MISSISSIPPI POWER & LIGHT COMPANY

August 24, 1981

Subject: Grand Gulf Nuclear Station
Units 1 and 2
Docket Nos. 50-416 and 50-417
Files 0260/0862
Transmittal of Proposed FSAR
Changes and Responses to NRC
Questions and SER Open Items
AECM-81/316

Fig. 1 Comparison of Full-scale Test Results with Predictions of NDRC Design Formula (3250-lb. Missile, Sharp-end Impact)

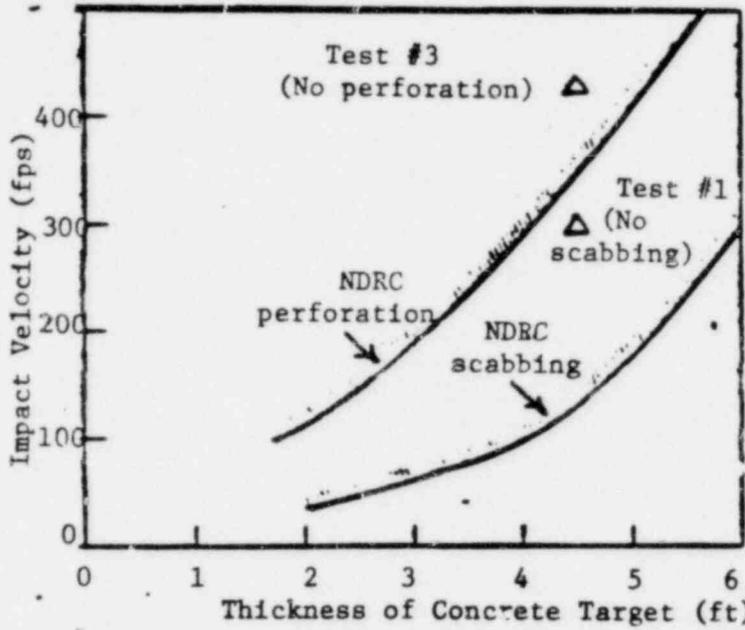
Protection against low trajectory missiles is provided by 4' - 6" thick shield walls which are located within very close proximity to the turbine generator. These barrier walls are designed to provide adequate protection against any postulated destructive overspeed missile. The Ballistics Research Laboratory (BRL) formula for concrete perforation was used to derive the required 4' - 6" concrete wall thickness. Conservatively, the last stage disk (Disk No. 5, Ref. 1) was used to represent the most damaging missile. This missile was assumed to have a velocity of a smaller disk (Disk No. 1). Therefore, the missile used in all barrier analysis had an initial energy greater than any missile postulated in Ref. 1. However, calculations indicated a margin of approximately 20% for the shield wall. The modified NDRC formula was considered too conservative and was not used in any calculations. This conservatism can be seen in the attached Figure 1 (Ref. 2) and Figure 2 (Ref. 3), which were originally presented at the April, 1981 EPRI Seminar on Steam Turbine Disc Integrity. All test data, either full or 1/11 scale representations of a Westinghouse 120° missile, showed that even though the NDRC formula predicted perforation, it did not occur. In one case, a missile with an initial velocity of 440 fps did not perforate a scale 3' - 6" barrier although the NDRC formula predicted perforation at an impact velocity near 200 fps.

Although the EPRI test program on turbine missiles is not complete, available data and the formula which is most representative of this data indicate that a 4' - 6" reinforced concrete barrier is sufficient to preclude perforation by any of the postulated turbine missiles at Grand Gulf.

Fig. 4. Perforation Comparison with CEA-EDF Data

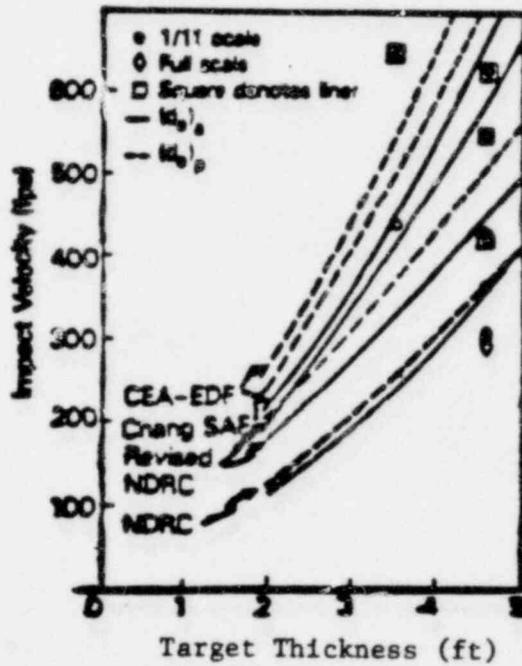
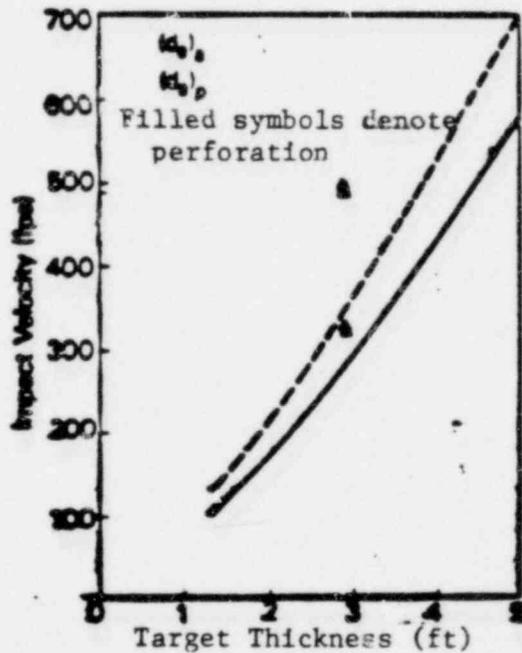
Since the initial study was completed, more test data has become available to justify the 4' - 6" wall thickness. Full scale test data (Ref. 2) and small scale test data (Ref. 5) using turbine missile shapes are now available and are summarized in Tables 1 & 2. These test results are included in Figure 2 which superimposes this data against several perforation formulas. The CEA-EDF and Chang formulas represent the data more closely than the NDRC formula. Twisdale (Ref. 3) and Sliter (Ref. 5) have both shown the CEA-EDF formula to have the most reasonable correlation with available test data. Also, Sliter (Ref. 6) analyzed the results of 145 missile tests involving steel missiles and reinforced concrete barriers. He found the CEA-EDF formula to best predict perforation thicknesses. In addition to correlating well with the EPRI turbine missile data, the CEA-EDF formula is further substantiated by the CEA-EDF data as reported by Twisdale (Ref. 3). These tests, involving an 8000 pound disk fragment, are summarized in Figure 4 with the superimposed CEA-EDF formula. The CEA-EDF formula was originally generated by the interpretation of 52 impact tests as reported by Sliter (Ref. 6).

Therefore, available test data indicates that the CEA-EDF formula best predicts concrete perforation due to turbine missile impact. Table 3 summarizes the required thickness of concrete, using the CEA-EDF formula, to protect against perforation by the five disks summarized by Allis-Chalmers (Ref. 1). The average area of impact was used in the calculations. In all cases, the 4' - 6" thickness provided by the shield wall is sufficient to preclude perforation by a significant margin.

Fig. 3. - Comparison of Concrete Perforation Analysis for a typical General Electric 120° Segment Turbine Missile

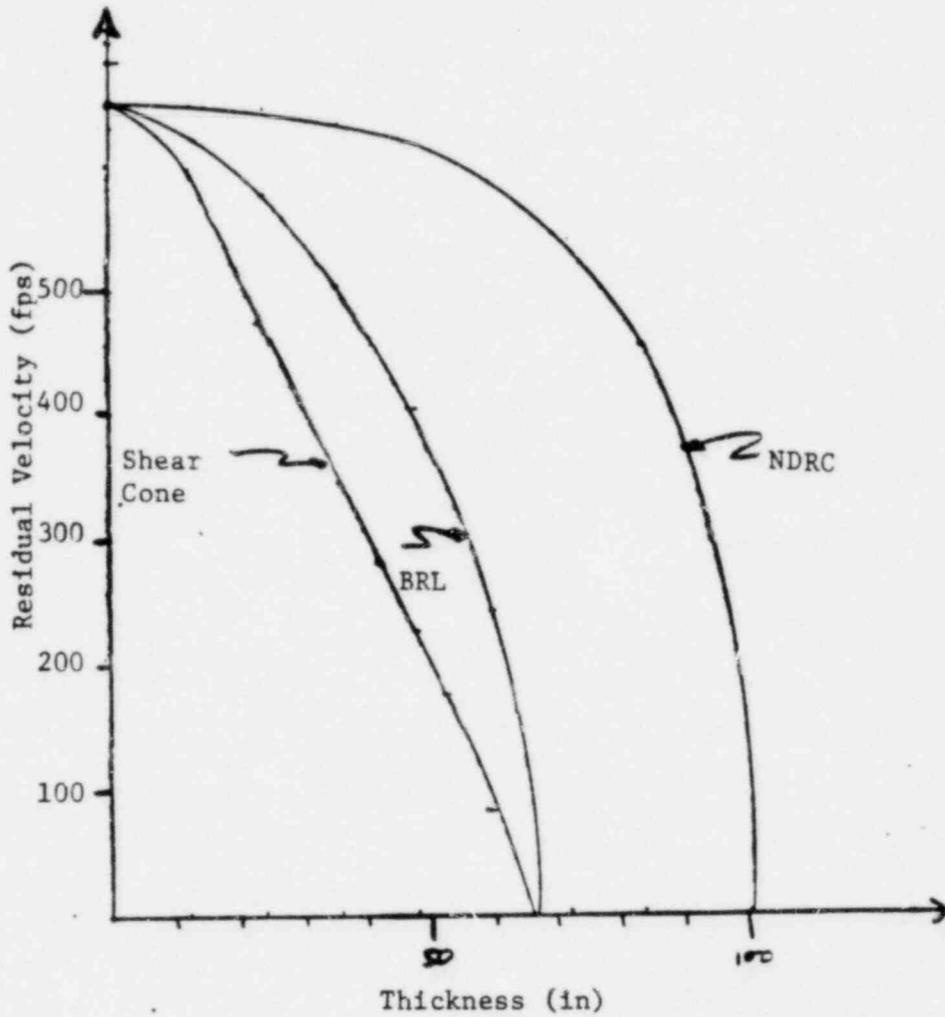
The BRL formulation was also selected because the results derived from its application to turbine missile barriers was very similar to results derived from a less empirical method developed by McMahon, Sen and Meyers (Ref. 4). This method calculates concrete perforation using an energy summation technique and is less sensitive to extrapolation beyond available data. Figure 3 shows a comparison of the three methods discussed above for a General Electric 120° missile. The semi-empirical and the BRL solutions compare favorably; however, the NDRC solution is significantly more conservative.
